Addendum No. 3

Coyote Valley Open Space Preserve Public Access Improvement Project

RFB-2026-03

March 18, 2026

L-1.0

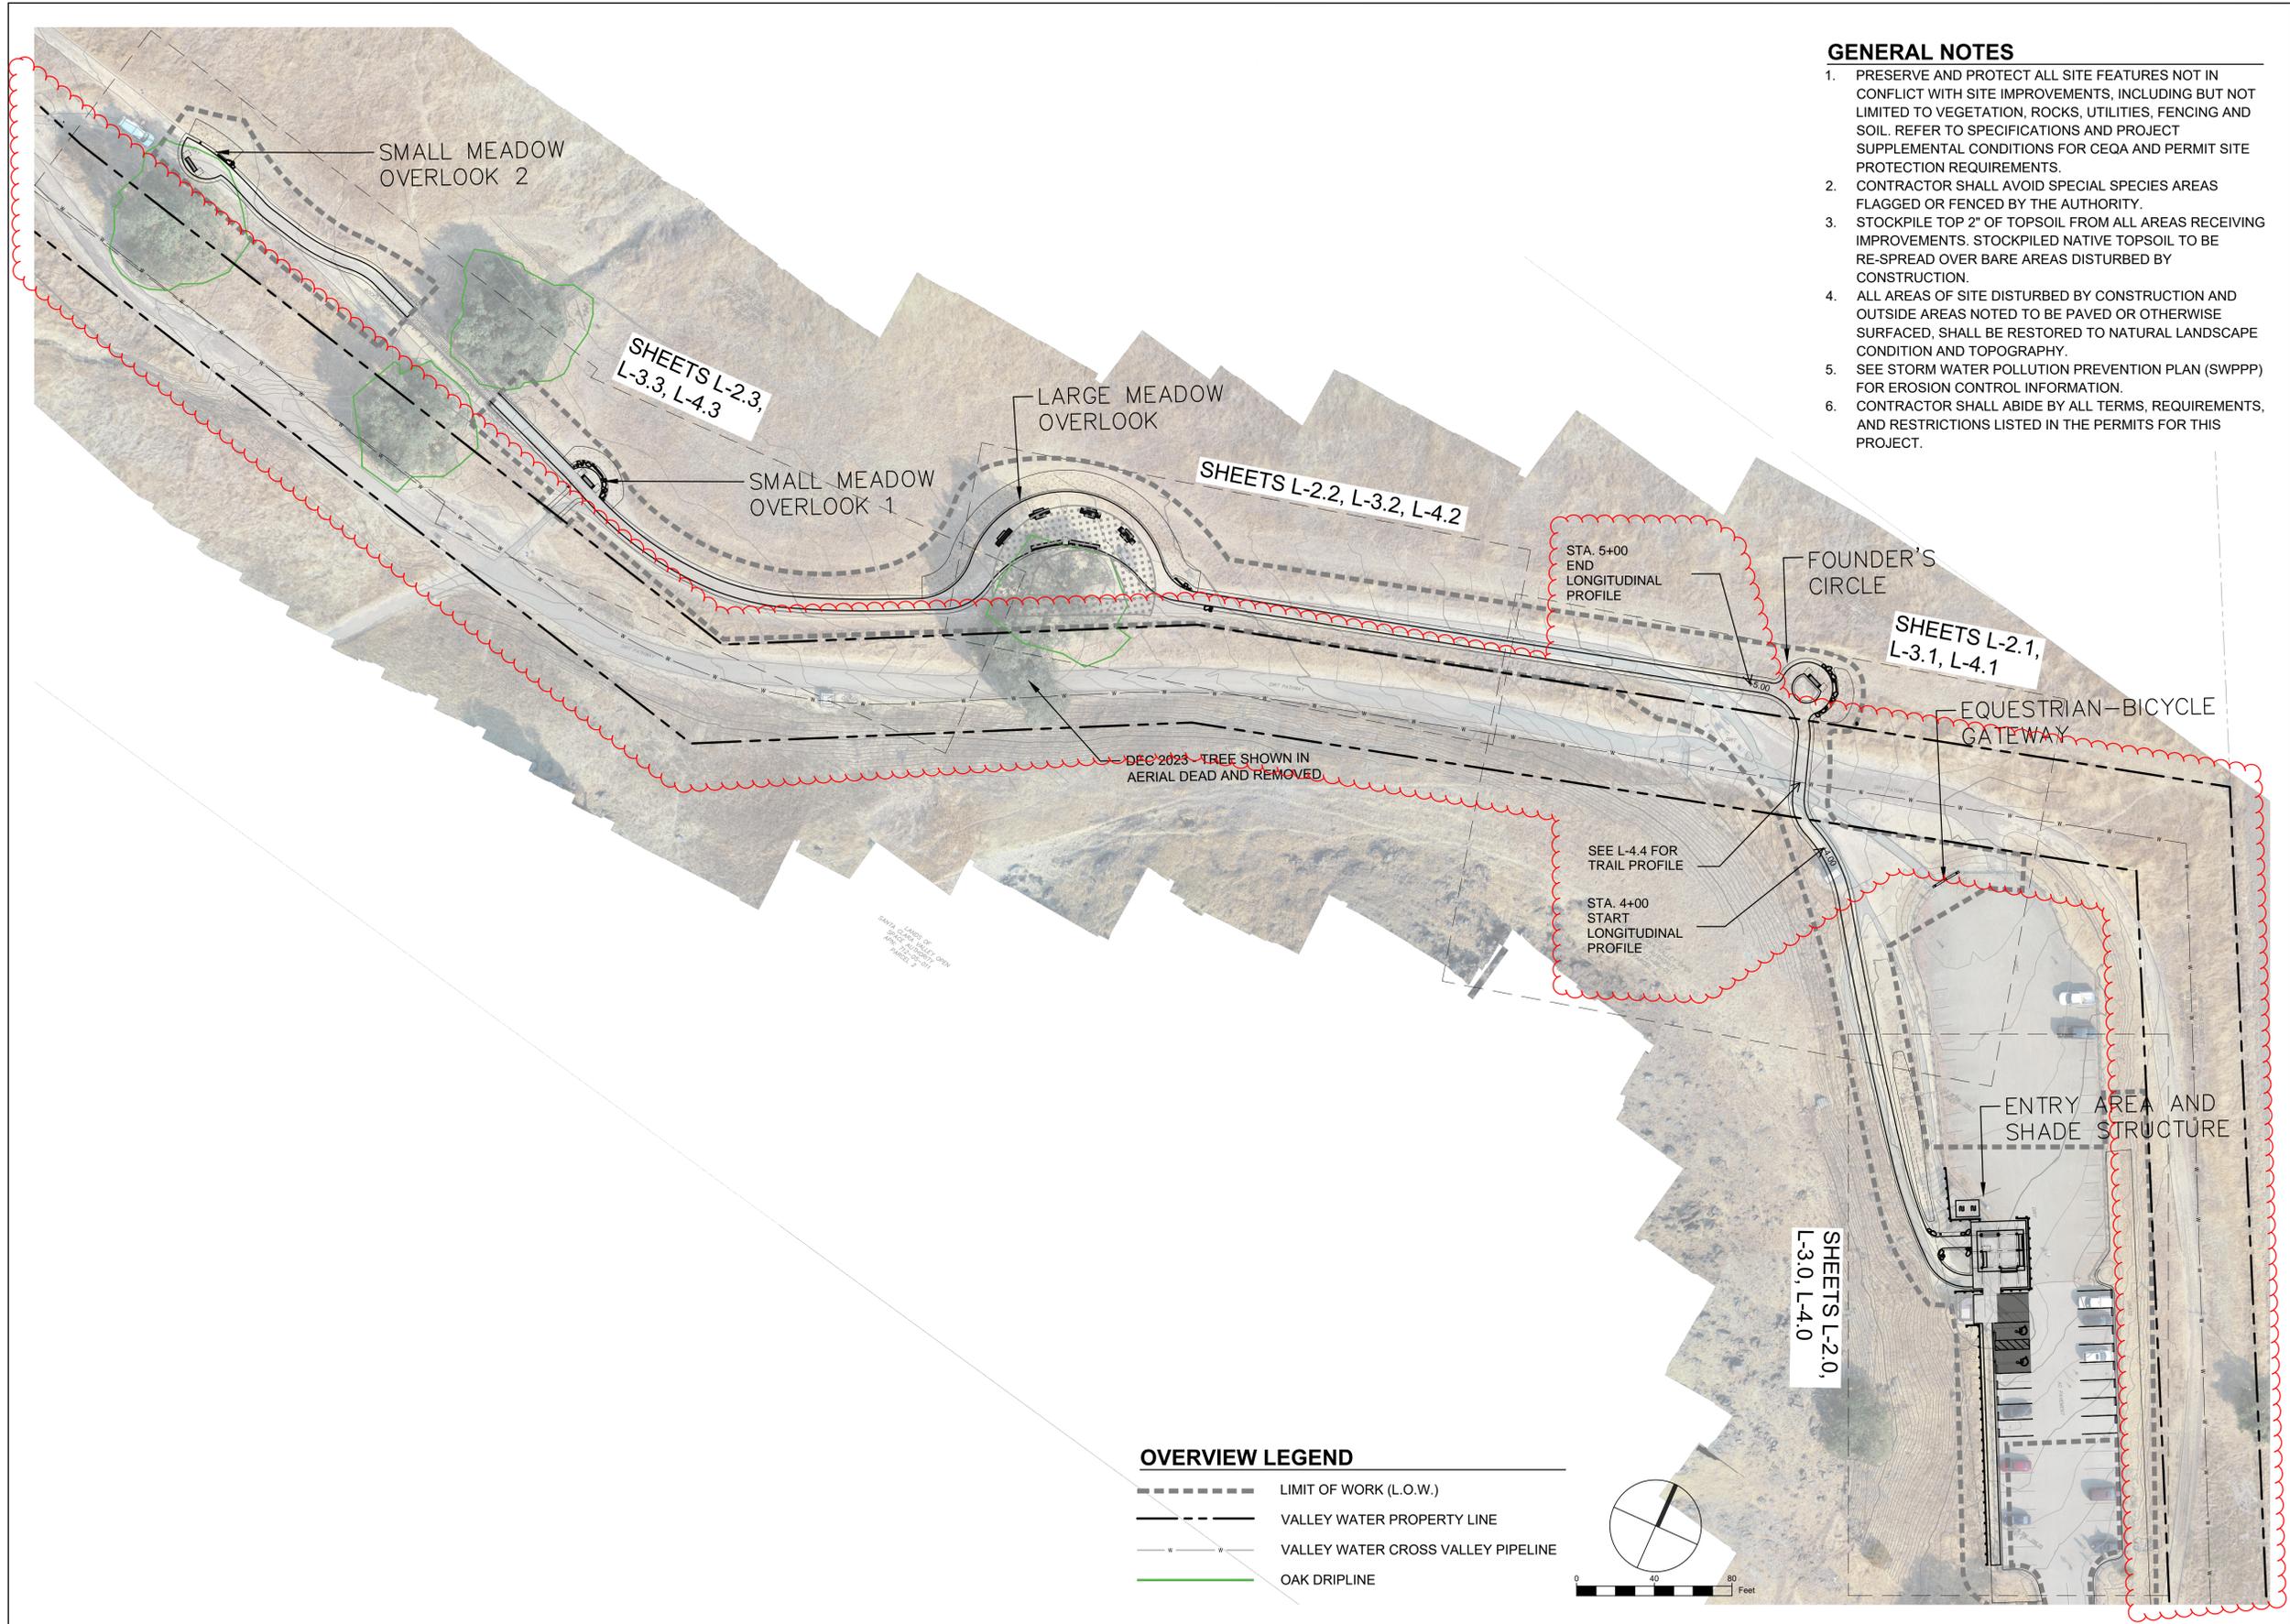
- c. *Please provide information regarding the buried SCVWD water line that runs adjacent to the project. Will we be able to cross it with heavy equipment? What is the depth of this pipe?*

1) See Addendum #3 L-1.0 and L-4.4. Revisions are clouded.

Answer: Refer to Addendum #3 L-1.0 and L-4.4. The water line is approximately 7'. Santa Clara Valley Open Space Authority will apply for the encroachment and construction access permit from SCVWD, and the contractor will be required to comply with the conditions of the permit. No restrictions on construction equipment access are known at this time.

SHEET NUMBER
ST-1
8 OF 16 SHEETS
SCALE
VERTICAL: 1" = 1'-0"
HORIZONTAL: 1" = AS SHOWN
JOB NUMBER
SJB037000

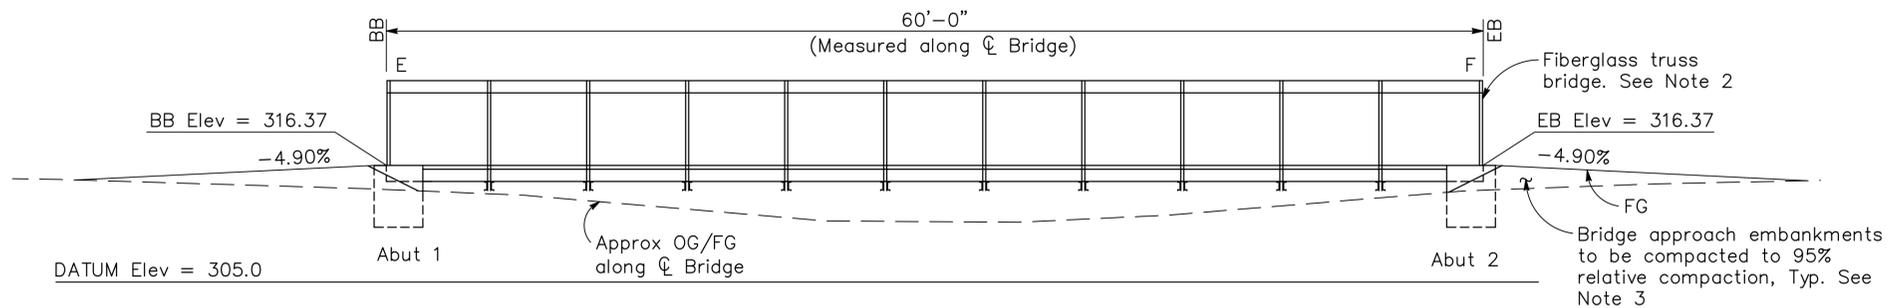
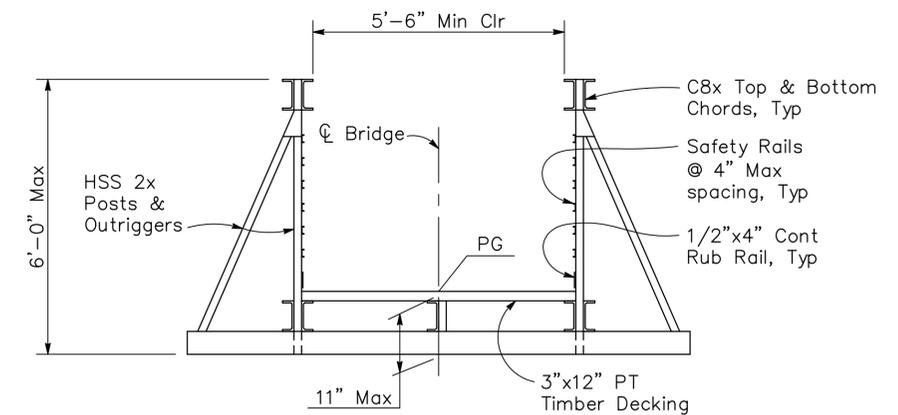
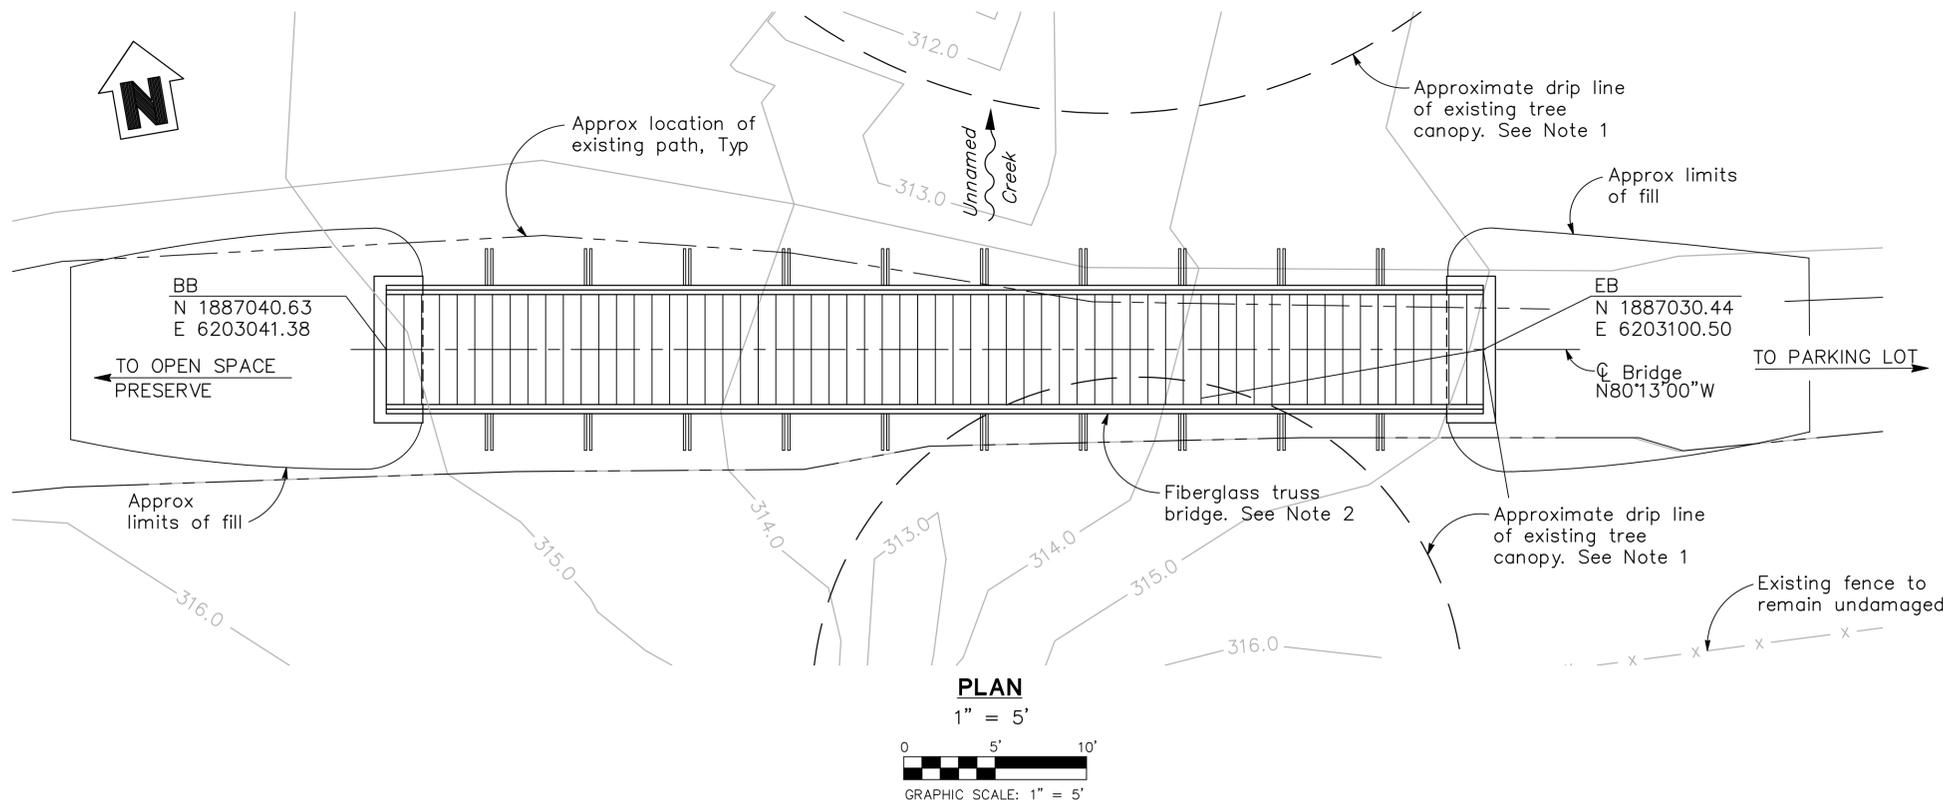
- b. *What is the weight limit for bridge on site that will need to be crossed to complete the pathway work?*

Answer: The clear width of bridge deck is 5'-6" by 60', designed for an 85 psf uniform pedestrian live load. Vehicular load capacity is unknown at this time. If bridge is proposed for construction access contractor shall consult with Santa Clara Valley Open Space Authority prior to placing any concentrated or heavy equipment loads on the bridge. See bridge construction drawings.
